項次	規章名稱	修訂內容	新增項目	頁碼	說明
1	2.4安全輔助評等規章-2.4.1乘員狀態監測系統評等	◎		P.2-51	依 Euro NCAP 安全輔助評等規章 10.4 版，修訂乘員狀態監測系統(OSM)之駕駛狀態監測系統(DSM)及安全帶提醒裝置(SBR)評等標準。
2	3.10緊急煞車輔助系統(車對車)試驗規章	◎		P.52-170	依 Euro NCAP 緊急煞車輔助系統試驗規章 4.3.1 版，新增轉彎穿越路徑情境試驗、直行交匯路徑情境試驗、前方對向來車直行情境試驗、前方對向來車變換車道情境試驗。
3	2.4安全輔助(SA)評等規章-2.4.3緊急煞車輔助系統(車對車)評等	◎		P.171-205	依 Euro NCAP 安全輔助評等規章 10.4.1 版，新增轉彎穿越路徑情境試驗、直行交匯路徑情境試驗、前方對向來車直行情境試驗、前方對向來車變換車道情境試驗之評等標準。
4	3.12車道輔助系統試驗規章	◎		P.206-243	依 Euro NCAP 車道輔助系統試驗規章 4.3 版，修訂緊急車道維持輔助系統(ELK)、車道維持輔助系統(LKA)、車道偏離輔助警示系統(LDW)以及盲點偵測系統(BSM)試驗情境。
5	2.4安全輔助評等規章-2.2.4車道輔助系統評等	◎		P.244-257	依 Euro NCAP 安全輔助評等規章 10.4.1 版，修訂緊急車道維持輔助系統(ELK)、車道維持輔助系統(LKA)、車道偏離輔助警示系統(LDW)以及盲點偵測系統(BSM)評等標準。
6	3.14盲點輔助系統試驗規章	◎		P.258-264	修訂盲點輔助系統試驗條文內容。
7	2.4盲點輔助系統評等規章	◎		P.265-266	依 TNCAP 第 29 次工作組會議決議，修訂盲點輔助系統(BSS)評等標準。

2.4.1乘員狀態監測系統評等 <<本案暫以2.4規章編號說明乘員狀態監測系統評等條文修訂內容，後續擬修訂至2.1安全駕駛評等規章 >>

Figure 3-2: Lateral path error

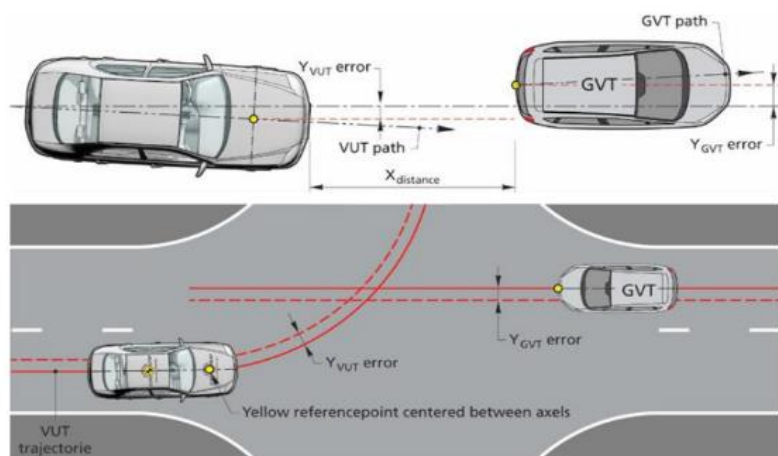
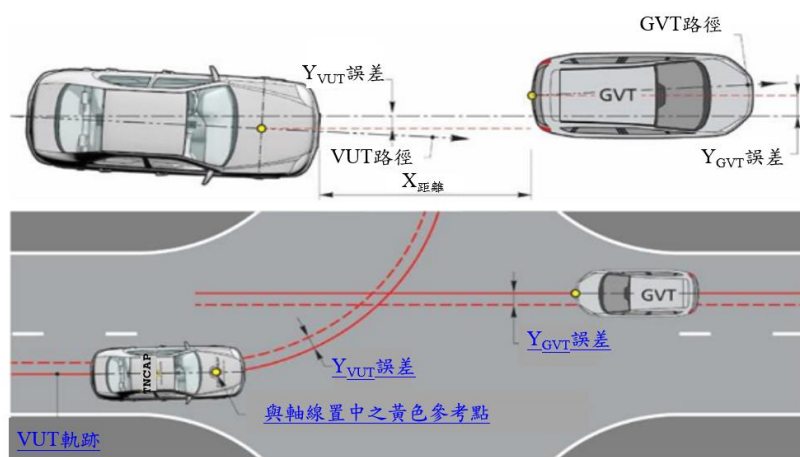
2025 年版 Euro NCAP 規章	2019 年版 Euro NCAP 規章	修訂 TNCAP 條文草案(第三版)	對應 TNCAP 第二版規章
 Figure 3-2: Lateral path error	 Figure 2: Lateral path error	(請參末頁圖示)	(請參末頁圖示)

圖3：側向偏移量

Figure 7-1: Layout of junction and the connecting lanes

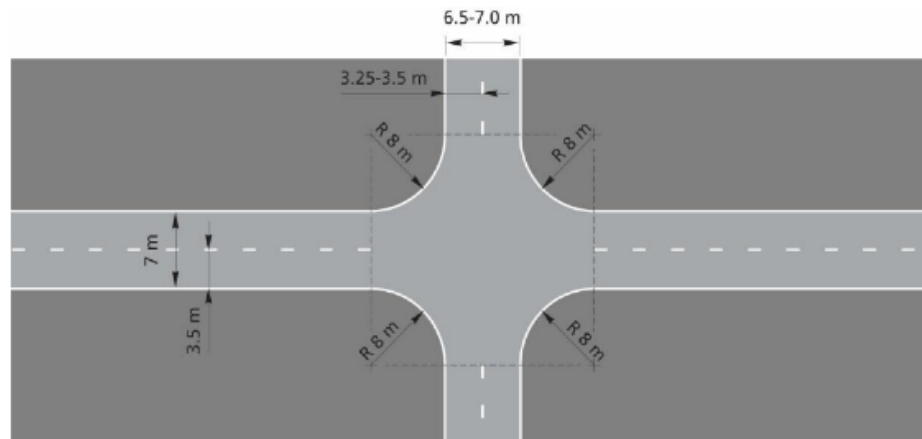
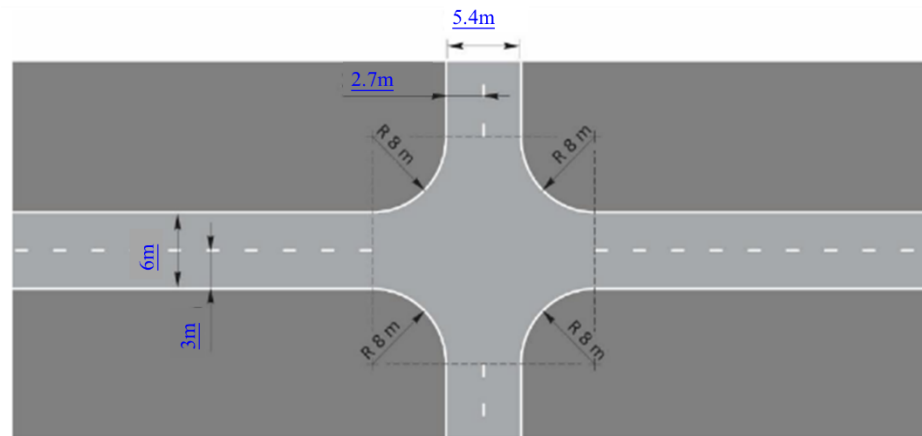
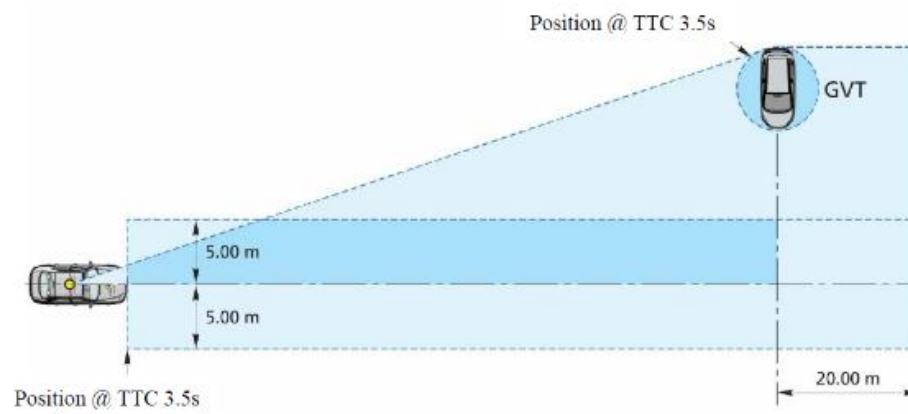
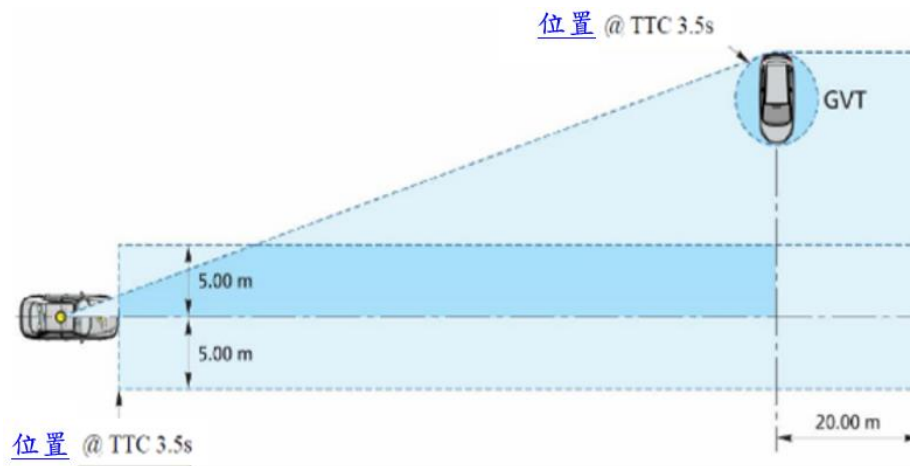
2025 年版 Euro NCAP 規章	2019 年版 Euro NCAP 規章	修訂 TNCAP 條文草案(第三版)	對應 TNCAP 第二版規章
7.1.4 Junction and Lane Markings 7.1.4.1 The CCFtap and CCCscp tests described in this document requires the use of a junction. The main approach lane where the VUT and GVT paths start, (horizontal lanes in Figure 7-1) will have a width of 3.5m. The side lane (vertical lanes in Figure 7-1) will have a width of 3.25 to 3.5m. The lane markings on these lanes need to conform to one of the lane markings as defined in UNECE Regulation 130: 1. Dashed line starting at the same point where the radius transitions into a straight line with a width between 0.10 and 0.15m 2. Solid line with a width between 0.10 and 0.25m 3. Junction without any central markings		<u>3.10.7.1.4 道路交匯處(Junction)與車道標線</u> <u>3.10.7.1.4.1CCFtap 與 CCCscp 試驗需使用道路交匯處。受驗車輛與全球目標車開始試驗之主車道(圖 7 之水平車道)及側車道(圖 7 之垂直車道)寬度不得小於 3m：</u> (1) <u>白虛線起始點應同外側標線半徑轉換為車道直線標線處，線寬為 10cm。應使用線段長 4m，間距 6m。</u> (2) <u>路面邊緣應使用白實線，線寬為 15cm。</u> (3) <u>無任何中心標線之道路交匯處。</u>

2025 年版 Euro NCAP 規章	2019 年版 Euro NCAP 規章	修訂 TNCAP 條文草案(第三版)	對應 TNCAP 第二版規章
 Figure 7-1: Layout of junction and the connecting lanes		(請參末頁圖示)	
7.2 Weather Conditions 7.2.1 Conduct tests in dry conditions with ambient temperature above 5°C and below 40°C. 7.2.2 No precipitation shall be falling and horizontal visibility at ground level shall be greater than 1km. Wind speeds shall be below 10m/s to minimise GVT and VUT disturbance. 7.2.3 Natural ambient illumination must be homogenous in the test area and in excess of 2000 lux for daylight testing with no strong shadows cast across the test area other than those caused by the VUT or GVT. Ensure testing is not	7.2 Weather Conditions 7.2.1 Conduct tests in dry conditions with ambient temperature above 5°C and below 40°C. 7.2.2 No precipitation shall be falling and horizontal visibility at ground level shall be greater than 1km. Wind speeds shall be below 10m/s to minimise GVT and VUT disturbance. 7.2.3 Natural ambient illumination must be homogenous in the test area and in excess of 2000 lux for daylight testing with no strong shadows cast across the test area other than those caused by the VUT or GVT. Ensure testing is not	3.10.7.2 天氣條件 3.10.7.2.1 試驗應於環境溫度 5°C 至 40°C 間之乾燥環境進行。 3.10.7.2.2 降雨時不得進行試驗，且地面水平能見度應大於 1km。風速應小於 10m/s，以使全球目標車與受驗車輛干擾應降至最低。 3.10.7.2.3 試驗區域的自然光線應均勻照射，白天試驗時照度應高於 2000lux，且除了受驗車輛與全球目標車之陰影外，不得有其他陰影籠罩試驗區域。試驗時應確保車輛行進方向非直接朝向或背向陽光之照射方	3.10.6.2 天氣條件 3.10.6.2.1 試驗應於環境溫度 5°C 至 40°C 間之乾燥環境進行。 3.10.6.2.2 降雨時不得進行試驗，且地面水平能見度應大於 1km。風速應小於 10m/s，以使全球目標車與受驗車輛干擾應降至最低。 3.10.6.2.3 試驗區域的自然光線應均勻照射，白天試驗時照度應高於 2000lux，且除了受驗車輛與全球目標車之陰影外，不得有其他陰影籠罩試驗區域。試驗時應確保車輛行進方向非直接朝向或背向陽光之照射方

圖7：道路交匯處與車道之示意圖

Figure 8-5: CCFtap scenario paths and impact definition

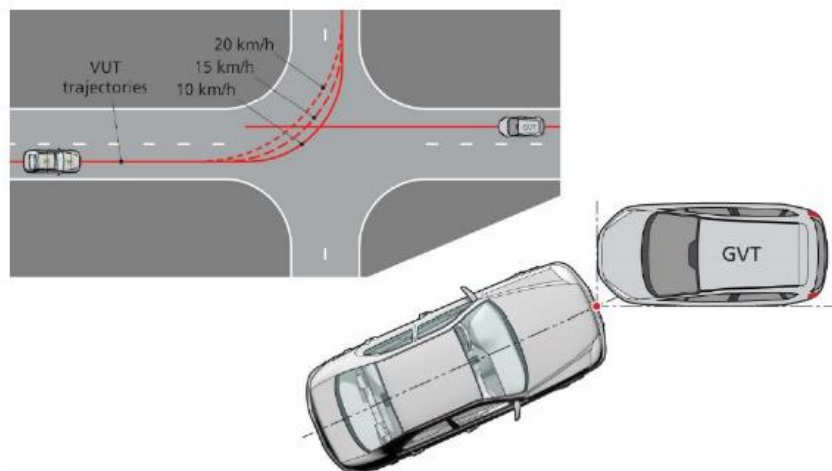
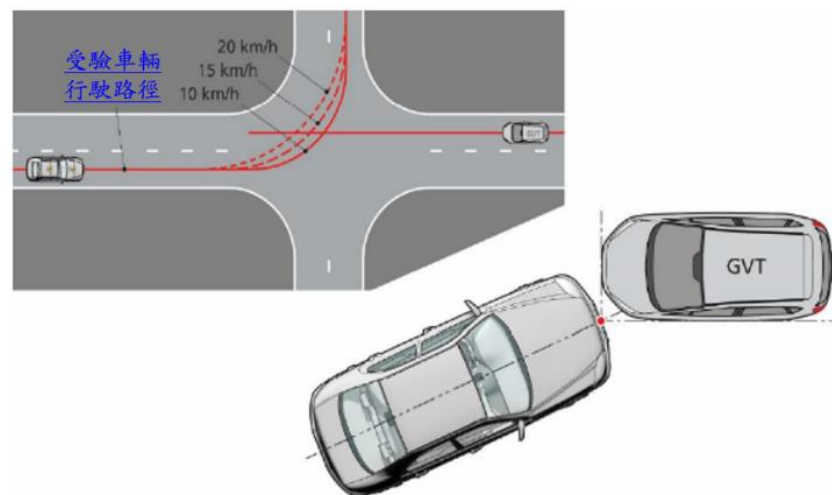
2025 年版 Euro NCAP 規章	2019 年版 Euro NCAP 規章	修訂 TNCAP 條文草案(第三版)	對應 TNCAP 第二版規章
Figure 8-5: CCFtap scenario paths and impact definition 8.2.3.4 The CCFtap scenarios are all combinations of VUT speeds of 10, 15 and 20 km/h combined with GVT speeds of 30, 45 and 60 km/h. 8.2.3.5 The following parameters should be used to create the test paths where the turn signal is applied at 1.0s $\pm$0.5s before T_{steer}:		(請參末頁圖示) 3.10.8.2.3.4 轉彎穿越路徑情境試驗皆為受驗車輛速度 10、15、20km/h 與全球目標車速度 30、45、60km/h 之組合。 3.10.8.2.3.5 試驗路徑應使用以下參數，其中轉向訊號應於 T_{steer} 前 1$\pm$0.5 秒發出。

圖14：轉彎穿越路徑情境試驗-行駛路徑與碰撞定義

Figure 8-6: CCFtap scenario paths definition

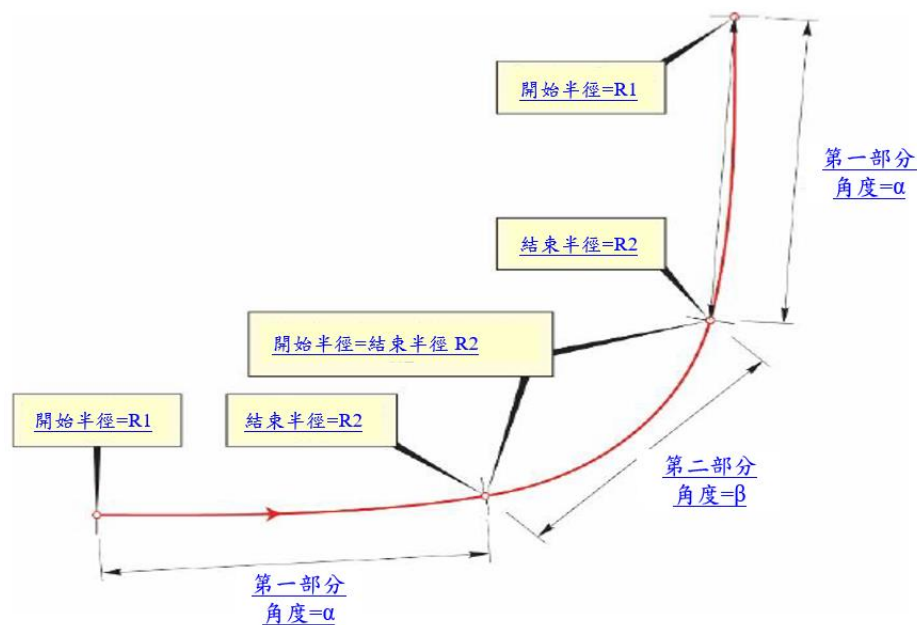
Figure 8-6: CCFtap scenario paths definition 8.2.4 Car-to-car Crossing Straight Crossing Path (CCCscp) 8.2.4.1 For the VUT assume a straight-line path equivalent to the centre line of the driving lane, approaching and continuing straight ahead across a junction. 8.2.4.2 For the GVT assume a straight-line path equivalent to the centre line of the driving lane, perpendicular to that of the VUT, travelling across the junction. The scenario is represented in	Test speed	Part 1 (clothoid)			Part 2 (constant radius)			Part 3 (clothoid)			Start Radius R1 (m)	End Radius R2 (m)	Angle α (deg)	Start Radius R1 (m)	End Radius R2 (m)	Angle β (deg)	Start Radius R1 (m)	End Radius R2 (m)	Angle α (deg)	10 km/h	1500	9.00	20.62	9.00	9.00	18.76	9.00	1500	20.62	15 km/h	1500	11.75	20.83	11.75	11.75	48.84	11.75	1500	20.83	20 km/h	1500	14.75	23.79	14.75	14.75	46.42	14.75	1500	23.79		(請參末頁圖示及表格) 3.10.8.2.4 直行交匯路徑情境試驗 3.10.8.2.4.1 受驗車輛行駛於車道中心線之直線路徑，接近並繼續直行穿越交匯處。 3.10.8.2.4.2 全球目標車行駛於車道中心線之直線路徑，垂直於受驗車輛路徑並穿越交匯處，試驗情境如圖 16 與圖 18 所示，其中「// - //」表示車輛位於行駛車道中心，對於靜止狀態	
Test speed		Part 1 (clothoid)			Part 2 (constant radius)			Part 3 (clothoid)																																												
	Start Radius R1 (m)	End Radius R2 (m)	Angle α (deg)	Start Radius R1 (m)	End Radius R2 (m)	Angle β (deg)	Start Radius R1 (m)	End Radius R2 (m)	Angle α (deg)																																											
10 km/h	1500	9.00	20.62	9.00	9.00	18.76	9.00	1500	20.62																																											
15 km/h	1500	11.75	20.83	11.75	11.75	48.84	11.75	1500	20.83																																											
20 km/h	1500	14.75	23.79	14.75	14.75	46.42	14.75	1500	23.79

圖15：轉彎穿越路徑情境試驗-行駛路徑定義

Figure 8-7 Straight Crossing Path VUT and GVT paths

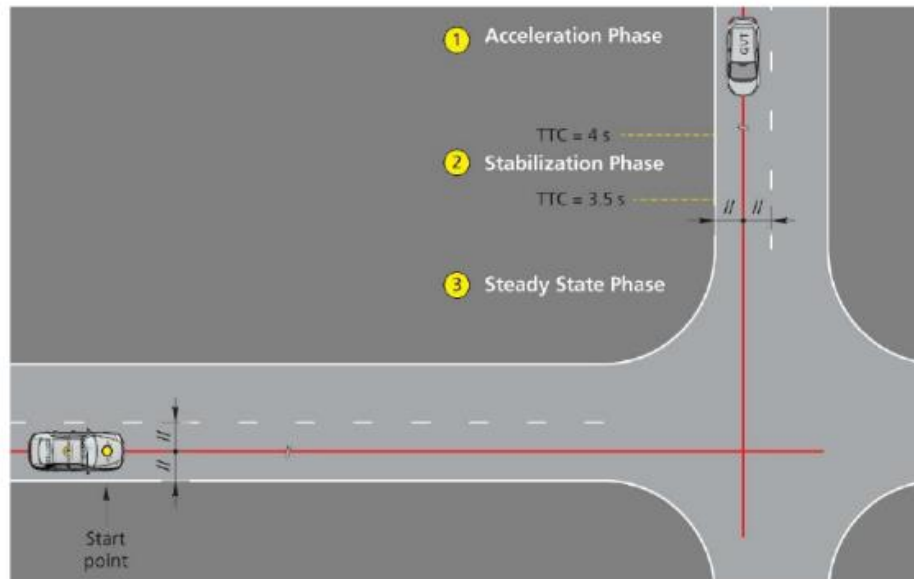
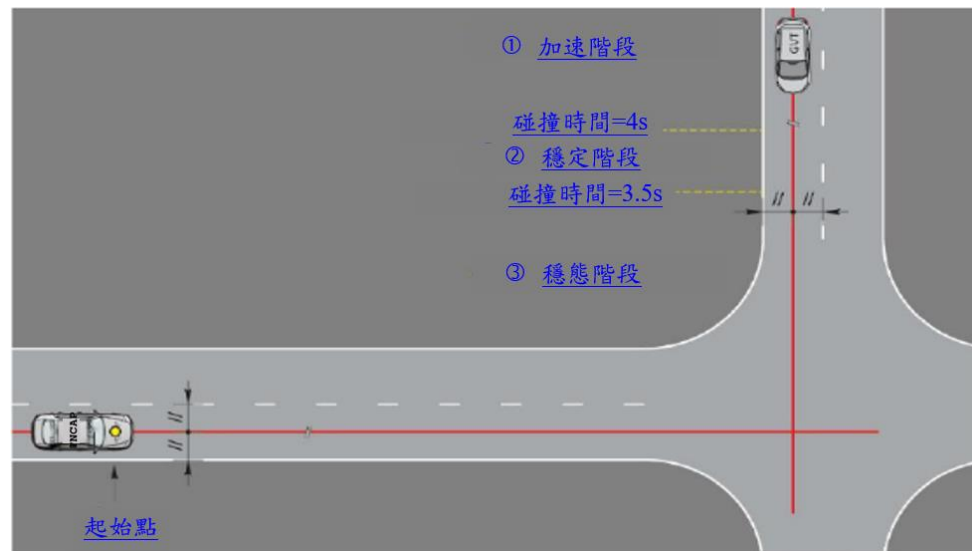
2025 年版 Euro NCAP 規章	2019 年版 Euro NCAP 規章	修訂 TNCAP 條文草案(第三版)	對應 TNCAP 第二版規章
Figure 8-7 Straight Crossing Path VUT and GVT paths and Figure 8-9 SCP start from stop setup, where ‘//-/’ indicates a vehicle being centred in the driving lane. For the start from stop tests the GVT travels across the junction from the farside direction. For all other test speed combinations the GVT will travel from either the nearside or farside direction, selected at random by the test laboratory. 8.2.4.3 To achieve the correct GVT speed, the GVT must be accelerated at a rate $>1\text{m/s}^2$ during the acceleration phase. This is followed by a 0.5s stabilization phase, after which steady state conditions must be met as per 8.4.2. 8.2.4.4 The paths will be synchronised to that the centre front of the VUT collides with the side of the GVT, 25% along the length of the GVT (assuming no system reaction).		<u>啟動試驗，全球目標車由遠端方向穿越交匯處；對於其他所有試驗速度組合，由執行機構與檢測機構共同隨機選擇全球目標車由遠端或近端方向行進。</u> <u>3.10.8.2.4.3 為達到正確的全球目標車速度，全球目標車於加速階段應以大於 1m/s^2 之加速度加速，接著是 0.5 秒的穩定階段，最後應滿足 3.10.8.4.2 節之穩態條件。</u> <u>3.10.8.2.4.4 試驗路徑將同步至受驗車輛中心前端與全球目標車車長 25% 處產生側面碰撞(若系統無作動)。</u>

2025 年版 Euro NCAP 規章	2019 年版 Euro NCAP 規章	修訂 TNCAP 條文草案(第三版)	對應 TNCAP 第二版規章
Figure 8-7 Straight Crossing Path VUT and GVT paths Figure 8-8 SCP Impact point definition 8.2.4.5 For the Start from stop scenario the VUT is at standstill with an initial longitudinal distance to the GVTs side of 2.9 m (Figure 8-9). Apply brake pedal to ensure that VUT is stationary until T_0 condition is reached, and then		(請參末頁圖示) (請參末頁圖示) 3.10.8.2.4.5 對於靜止狀態啟動情境， 受驗車輛初始為靜止狀態，與全球目標車之縱向距離為 2.9m(圖 18)，踩下煞車踏板以確保受驗車輛為靜止狀態，直到達到 T_0 條件，接著依照 3.10.11 所述執行油門踏板設定，確認

圖16：直行交匯路徑情境試驗-受驗車輛與全球目標車行駛路徑

圖21：前方對向來車變換車道情境試驗-70km/h及50km/h路徑

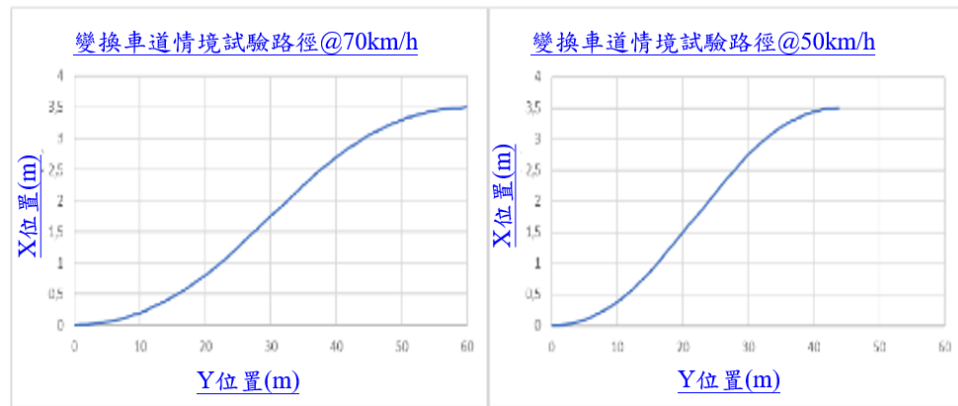
8.2.5.7 For the CCFhol scenario, the GVT will follow an initial straight-line path followed by a lane change manoeuvre at a constant speed equal to that of the VUT. The scenarios are represented in Figure 8-10 CCFhos and Figure 8-12 CCFhol path at 70 and 50		3.10.8.2.5.7 對於前方對向來車變換車道情境試驗，全球目標車行駛於初始路徑，接著與受驗車輛相同之穩定速度進行變換車道，前方對向來車直行情境試驗如圖 19，前方對向來車變換車道情境試驗 70km/h 與 50km/h 路徑如圖 21，其詳細資料參 3.10.10。

2025 年版 Euro NCAP 規章	2019 年版 Euro NCAP 規章	修訂 TNCAP 條文草案(第三版)	對應 TNCAP 第二版規章
km/h Details on VUT path is given on ANNEX B: Lane Change Path Definition.  Figure 8-10 CCFhos  Figure 8-11 CCFhol  Figure 8-12 CCFhol path at 70 and 50 km/h 		(請參末頁圖示及表格)

Figure 8-13 CCFhol curvature values at 70 and 50 km/h

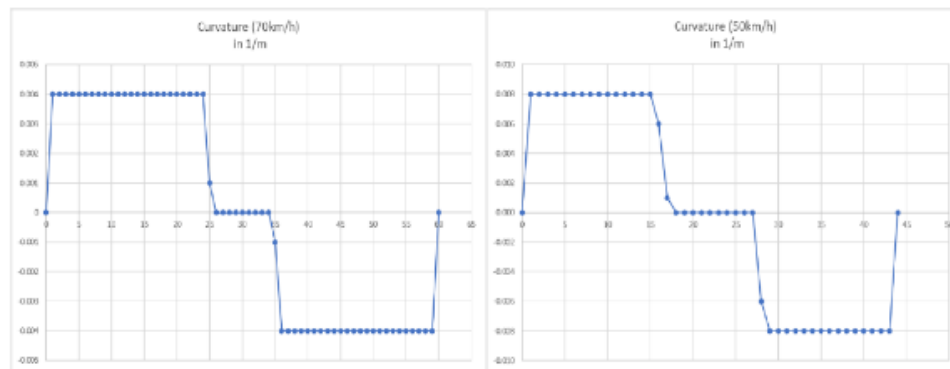
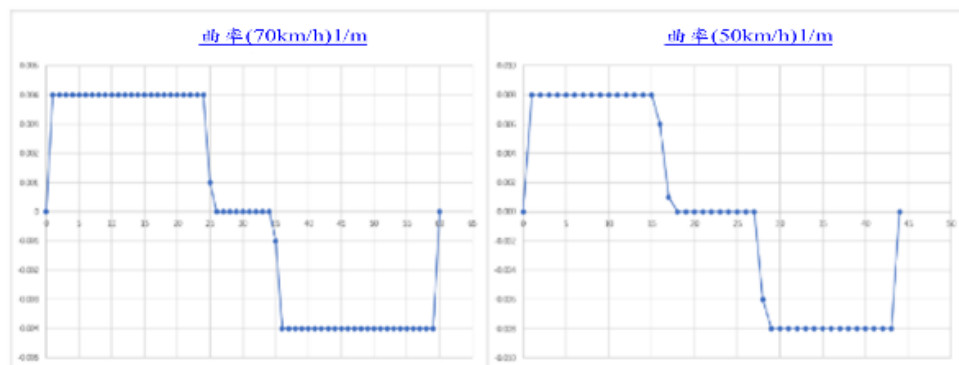
2025 年版 Euro NCAP 規章	2019 年版 Euro NCAP 規章	修訂 TNCAP 條文草案(第三版)	對應 TNCAP 第二版規章																					
Figure 8-13 CCFhol curvature values at 70 and 50 km/h

圖22：前方對向來車變換車道情境試驗-70km/h及50km/h曲率

Figure 1: ESS Test diagram using CCRs -50 scenario

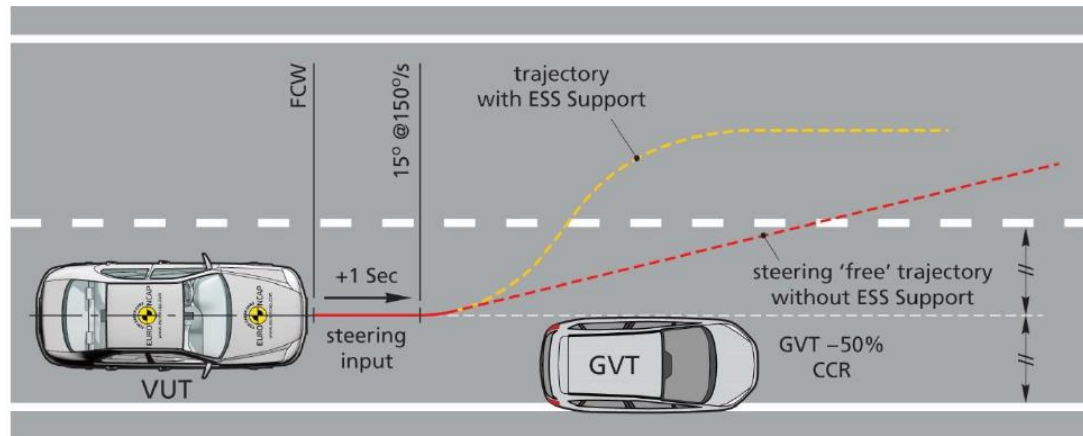
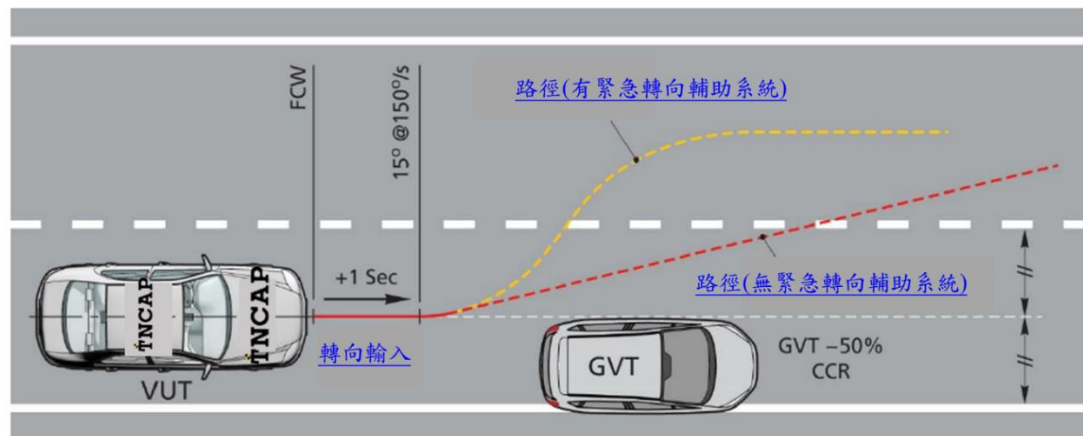
2025 年版 Euro NCAP 規章	2019 年版 Euro NCAP 規章	修訂 TNCAP 條文草案(第三版)	對應 TNCAP 第二版規章
after TTC=0. 4. Test Execution 4.1 ESS test parameters to apply 4.1.1 The test shall be performed in two fully marked lanes, each lane shall be 3.5m in width with solid lines on the outside. See Figure 1  Figure 1: ESS Test diagram using CCRs -50 scenario 4.1.2 The VUT is driven in a straight line in the middle of the ego lane in accordance with the tolerances specified in the relevant AEB C2C or VRU AEB testing protocols. 4.1.3 For CCRs -50, the GVT shall be set		<u>剩餘距離小於-0.3m)。</u> <u>3.10.8.4.7.3 緊急轉向輔助系統試驗程序</u> <u>3.10.8.4.7.3.1 應採用緊急轉向輔助系統試驗參數。</u> <u>3.10.8.4.7.3.2 試驗應於兩條具備完整標線之車道進行，每條車道寬度不得小於 3m，且外側為實線，如下圖所示。</u> (請參末頁圖示) <u>3.10.8.4.7.3.3 受驗車輛應依據緊急煞車輔助系統(車對車)或(弱勢道路使用者)試驗規章中定義之容許誤差，於車道中央直線行駛。</u> <u>3.10.8.4.7.3.4 對於前車靜止情境試驗-</u>

2025 年版 Euro NCAP 規章	2019 年版 Euro NCAP 規章	修訂 TNCAP 條文草案(第三版)	對應 TNCAP 第二版規章
to -50% overlap position relative to the VUT, see Figure 1 (where applicable).  Figure 1: ESS Test diagram using CCRs -50 scenario 4.1.4 Alternatively, for VRU scenarios the EPT or EBT shall be set to CPLA25 or CBLA25 scenarios respectively, see Figure 2 (where applicable).  Figure 2: ESS Test diagram using CPLA25 scenario 4.1.5 At a time of 1 second after FCW initiation, a steering wheel input shall be applied to the VUT's steering wheel with an angular rate of $150^{\circ}/s^1$. The 1 second delay to the steering input corresponds to a typical driver reaction time.		<u>50%，全球目標車相對於受驗車輛之位置應設定為-50%重疊，如下圖所示（若適用）。</u> <u>(請參末頁圖示，同 3.10.8.4.7.3.2 圖示)</u> <u>3.10.8.4.7.3.5 對於弱勢道路使用者情境試驗，目標行人或目標自行車騎士應分別設定為前端成人碰撞情境試驗 25%或前端自行車騎士碰撞情境試驗 25%，如下圖所示（若適用）。</u> <u>(請參末頁圖示)</u> <u>3.10.8.4.7.3.6 前方碰撞預警發出 1 秒後，應對受驗車輛之方向盤施加轉向輸入，其方向盤角速度應為 $150^{\circ}/s$，方向盤輸入延遲 1 秒，對應於一般駕駛的反應時間。</u>

Figure 7-1 : Vehicle paths definition

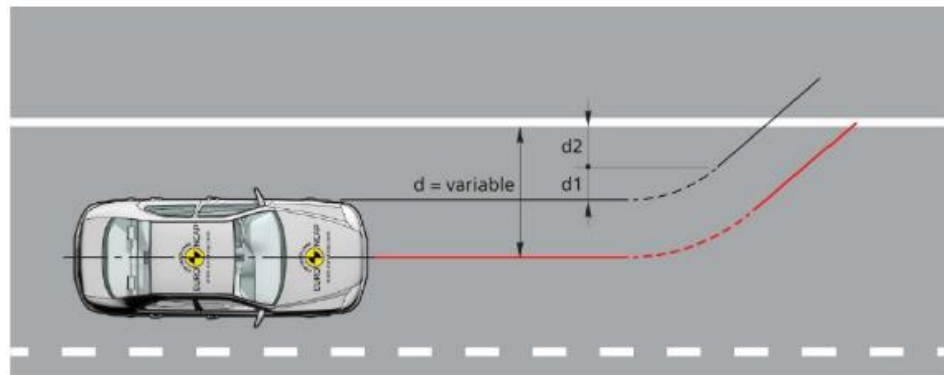
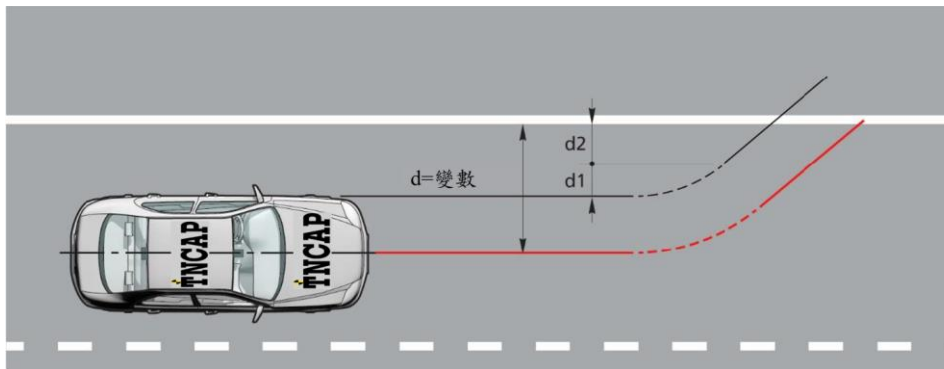
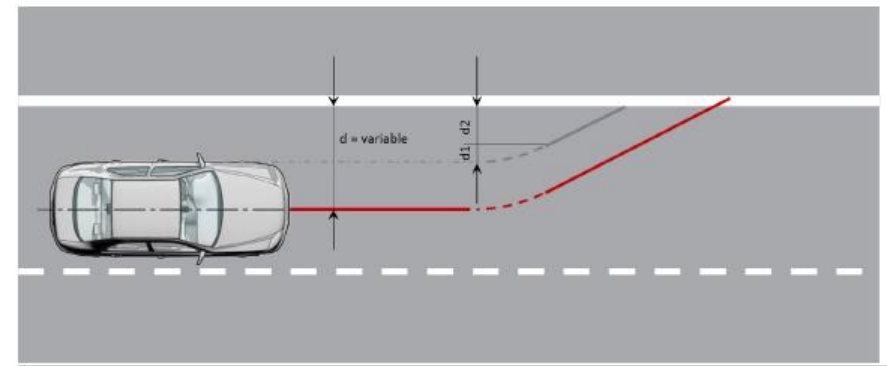
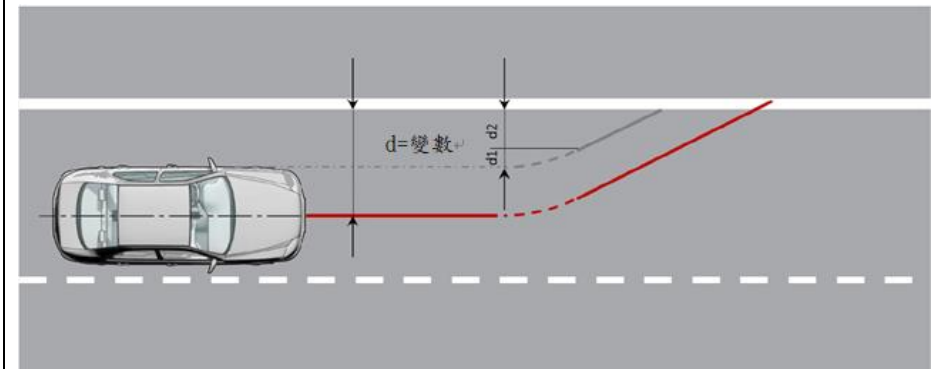
2025 年版 Euro NCAP 規章	2019 年版 Euro NCAP 規章	修訂 TNCAP 條文草案(第三版)	對應 TNCAP 第二版規章
d1: Lateral distance travelled during curve establishing yaw angle (m) d2: Lateral distance travelled during V_{lat} steady state (m)  Figure 7-1: Vehicle paths definition	d1: Lateral distance travelled during curve establishing yaw angle (m) d2: Lateral distance travelled during V_{lat} steady state (m) 	離 (m) d2:側向速度穩定狀態之側向偏離距離 (m) (請參末頁圖示)	離 (m) d2:側向速度穩定狀態之側向偏離距離 (m) (請參末頁圖示)

圖7：車輛路徑
